**SUBJECT: NRC INSPECTION REPORT NO. 70-27/2010-003 AND NOTICE OF VIOLATION**

Report No.: 70-27/2010-003

Babcock and Wilcox  
NRC Integrated Inspection Report 70-27/2010-003  
July 1 – September 30, 2010

**Figure 1 – High-Level Dissolver Enclosure Top View**

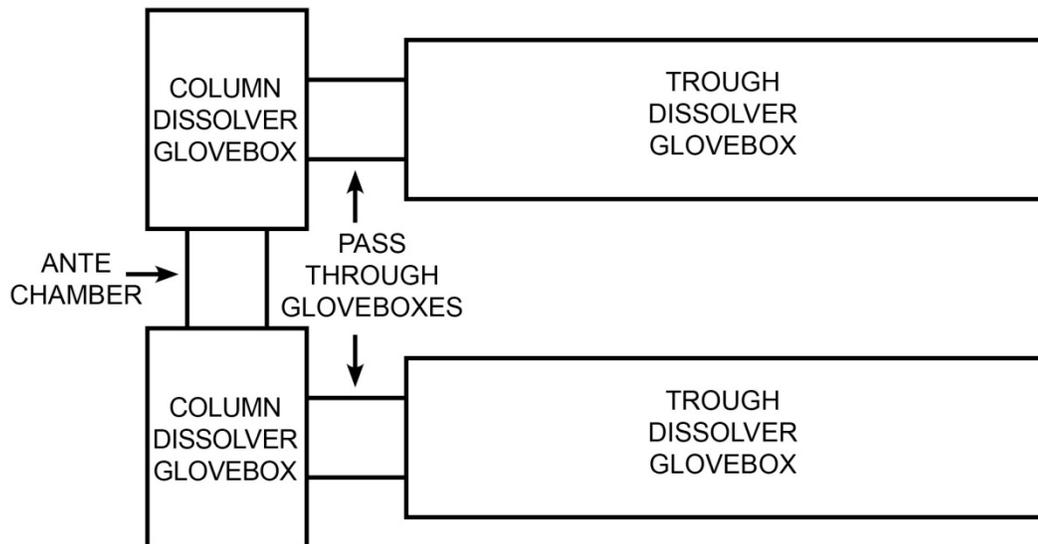
The licensee dissolves high-enriched uranium in two trough dissolvers in the uranium recovery area. The trough dissolvers are part of a large enclosure consisting of six gloveboxes and an ante-chamber. The enclosure arrangement (shown in Figure 1) consists of two column dissolver gloveboxes, two trough dissolver gloveboxes, two pass-through gloveboxes each connecting a column dissolver glovebox with a trough dissolver glovebox and an ante-chamber connecting the two column dissolver gloveboxes. The column dissolver and trough dissolver gloveboxes have multiple drains but the pass-through gloveboxes did not have drains.

Following glovebox flushing operations on June 11, 2010, UR area operators observed approximately one-liter of solution at the bottom of one of the pass-through gloveboxes in the high-level dissolver enclosure. The concentration of the solution was determined to be 26 grams U-235/liter. After the event the licensee cleaned both pass-through gloveboxes to remove any residual material that was in the pass-through gloveboxes. The licensee measurements indicated that a total of 111.65 grams of solid U-235 was

The inspectors reviewed the criticality safety analysis for the process and interviewed the responsible criticality engineer. The original analysis for the process did not anticipate or analyze for the presence of solution or material being left in the pass-through glovebox. The inspectors determined that the 26 grams U-235/liter solution that was found in the pass-through glovebox was below the license limit of 573 grams of U-235 for a fully reflective system ( $k$ -effective = 0.95). The solution was more than a minor safety concern because the licensee had failed to analyze the accident sequence and therefore the licensee had failed to establish IROFS to prevent a nuclear criticality accident in the pass-through glovebox.

License Application Section 5.1.1 states, in part, that the licensee is committed to conducting NCS evaluations to assure that under normal and credible abnormal conditions, all nuclear processes will remain subcritical and maintain an approved margin of subcriticality for safety. Under Section 5.1.1, the licensee is also committed to establishing and maintaining NCS IROFS, based on current NCS evaluations. The failure to conduct an NCS evaluation and establish and maintain NCS IROFS against the accumulation of fissile solution in the unsafe geometry pass-through glovebox is Violation (VIO) 70-27/2010-003-02.

Following clean out of the residual material in the pass-through gloveboxes, the licensee shut down the system and initiated a corrective action (CA201001322) to investigate the event. The investigation determined that fumes from dissolution of uranium in the trough dissolver entered the pass-through glovebox over time and adhered to the inner walls. Also, aqueous solution entered the pass-through glovebox from the trough dissolver through the hatchway during trough dissolver cleaning operations between dissolution batches when the water hose is directed at the hatchway. This resulted in fissile solution in the bottom of the pass-through glovebox where it was difficult to see due to the enclosure configuration and lighting. The licensee investigation did not identify fume penetration into the ventilation system.
